AMENDMENTS TO THE DRAWINGS

S/N 10,713,437
ANNOTATED SHEET

REMARKS

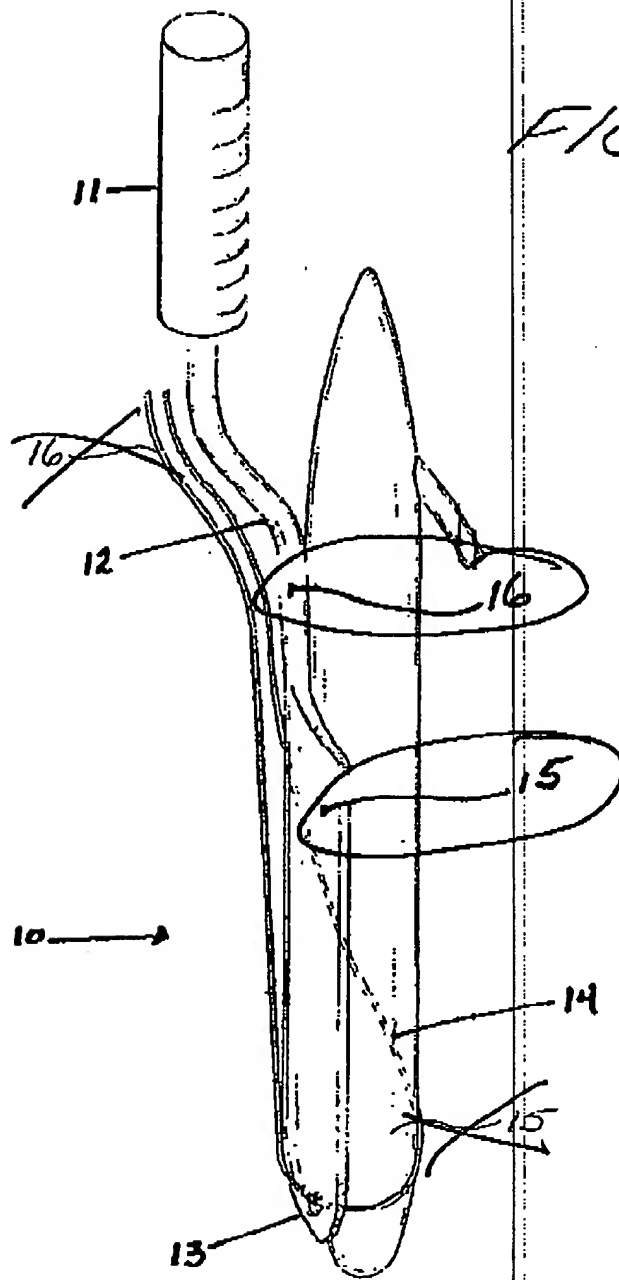
Fig. 1 has been amended to include additional item numbers that correspond with the description amended in the specification. Specifically, item numbers 15 and 16 have been added to Fig. 1, wherein item number 15 is the outwardly angled shaft section and item number 16 is the linear handle section.

Applicant has amended Fig. 1 to include additional item numbers that correspond with the description amended in the specification. Specifically, item numbers 15 and 16 have been added, wherein item number 15 is the outwardly angled shaft section and item number 16 is the linear handle section. The location of item numbers 15 and 16 have changed from the last amendment. The outwardly angled shaft section 15 is outwardly angled from the center line of the linear handle section. The portion of the outwardly angled shaft section 15 that is visible on Fig. 1 is replicated on the other side of the tool, and together, the outwardly angled shaft section and its replicate form a convexity, or a roundness in the tool so that it may fit over the rounded prosthesis. Applicant submits that the drawings should now be clear and requests that the objection to the drawings be withdrawn.

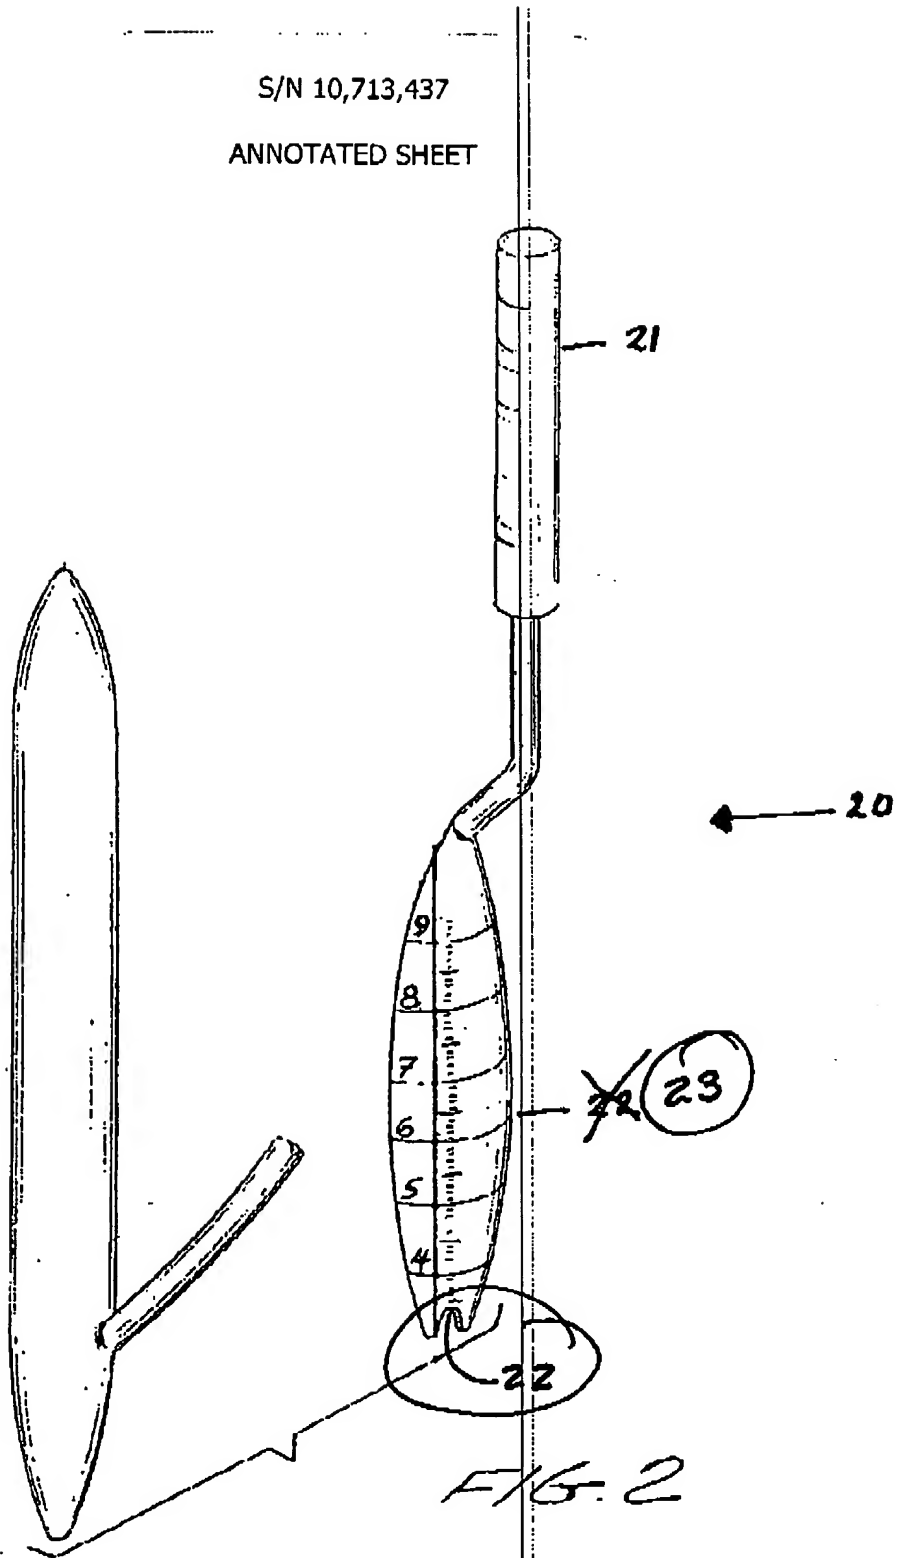
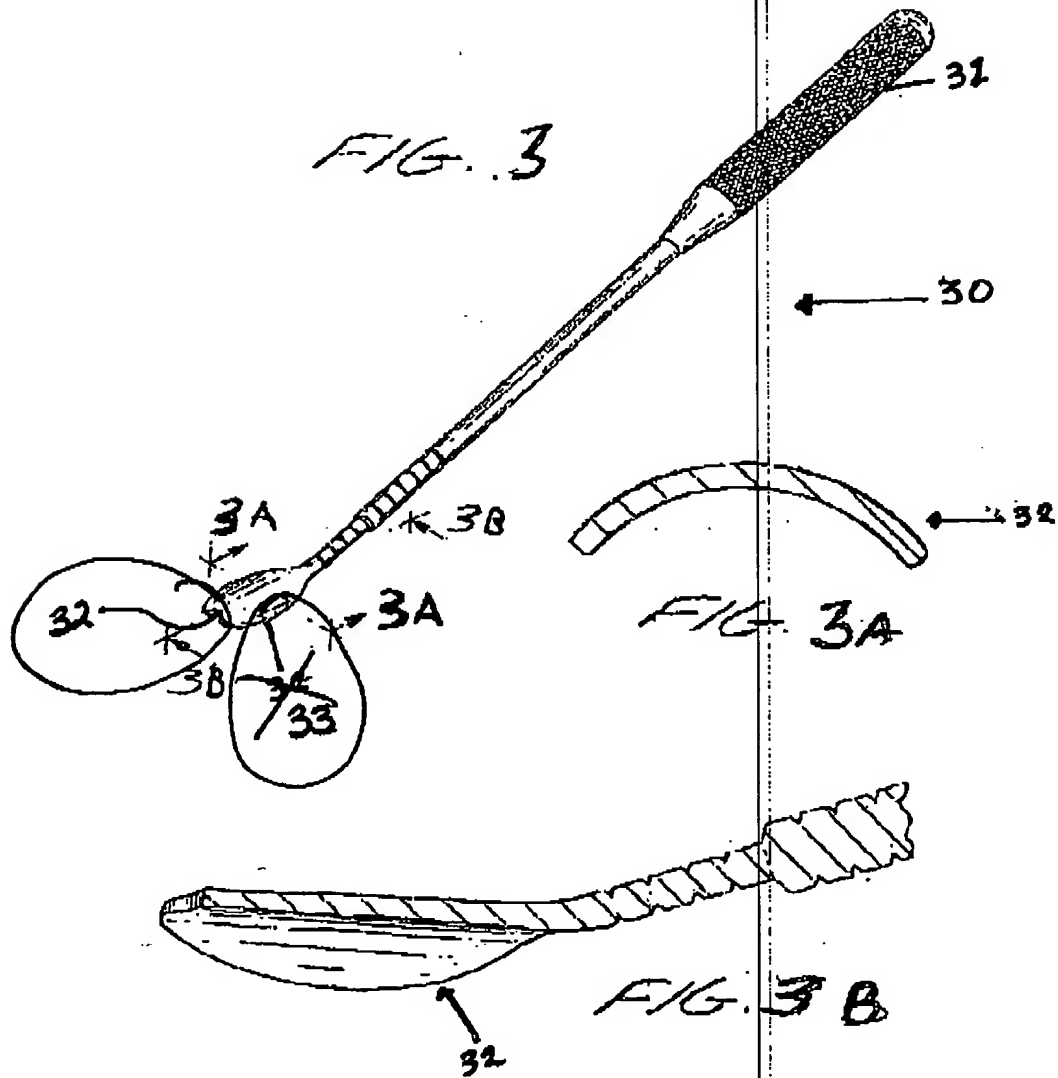
Figs. 2 and 3 have been amended to include additional item numbers that correspond with the description amended in the specification. Specifically, item numbers 23 and 33 have been added to identify the shaft. Item numbers 22 and 32 have been moved to point more particularly to the receptacle (notch) of the tool.

Applicant has amended Figs. 2 and 3 to add item numbers 23 and 33 which identify the shaft, in cooperation with the amendment to the specification presented above. Item numbers 22 and 32 have been moved on the drawing to show that they refer to the notch, or receptacle, at the end of the shaft of the tool.
